*City of Portsmouth
Public Works Department*

**Addendum #1
Parrott Ave Parking Lot Project
Bid Proposal #14-16**

Issued September 17, 2015

This addendum forms part of the original document marked: **Bid Proposal #14-16 – Parrott Ave Parking Lot Paving**. Please acknowledge this addendum within your proposal, failure to do so may subject a bidder to disqualification. Failure to acknowledge receipt of the Addendum may subject the Bidder to disqualification.

SCALE 1"=20'

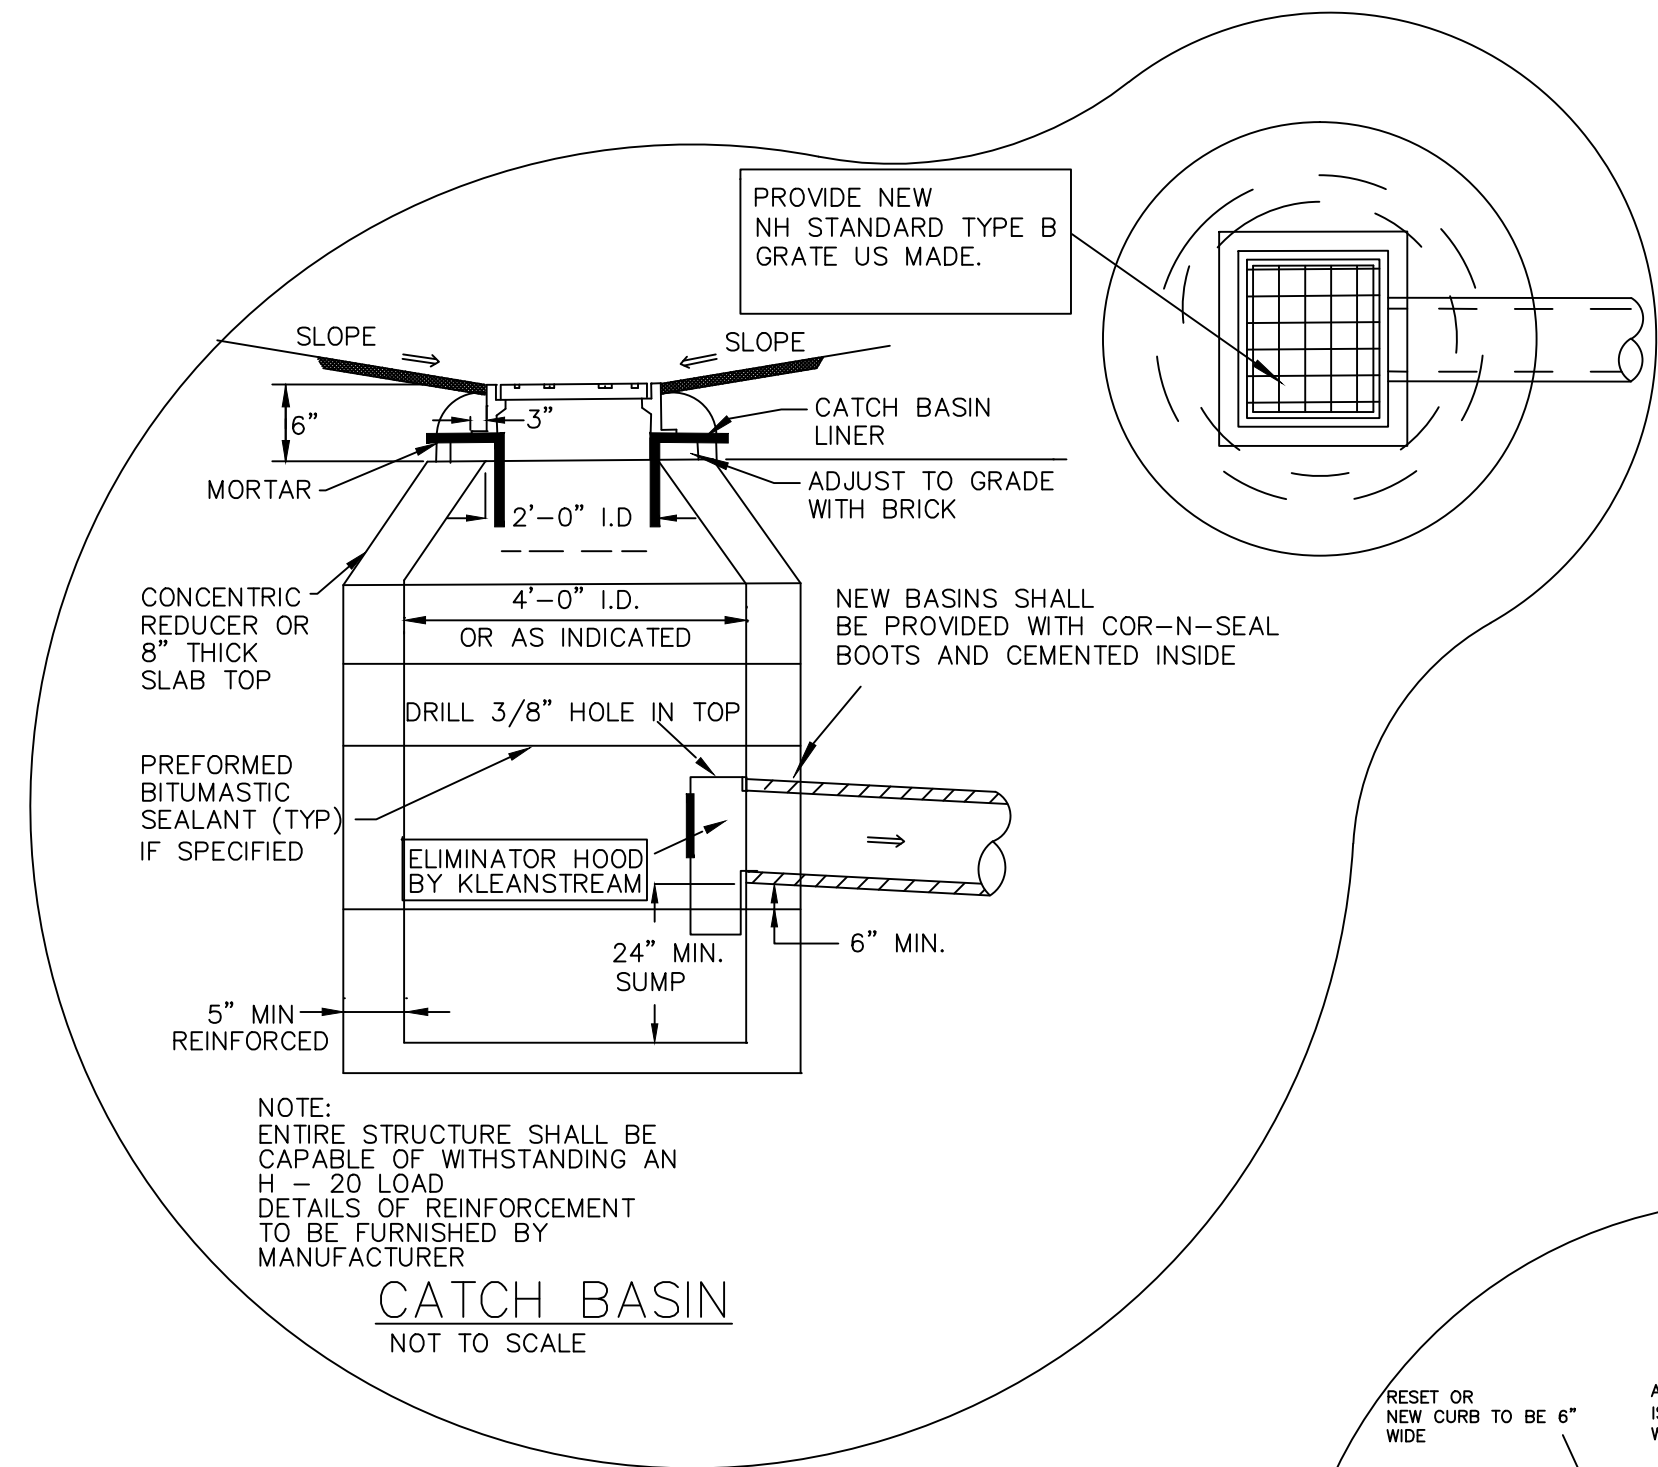
Item 1-8 Construction Details

The Light Pole Base detail has been changed to 30" diam. X 6' length to accommodate the revised light specified under the base bid.

The Light Pole Base detail for the bid alternative has been labeled as such. This is the original Light Pole Base specified for the Holophane lights which are now the Alternate Bid Item.
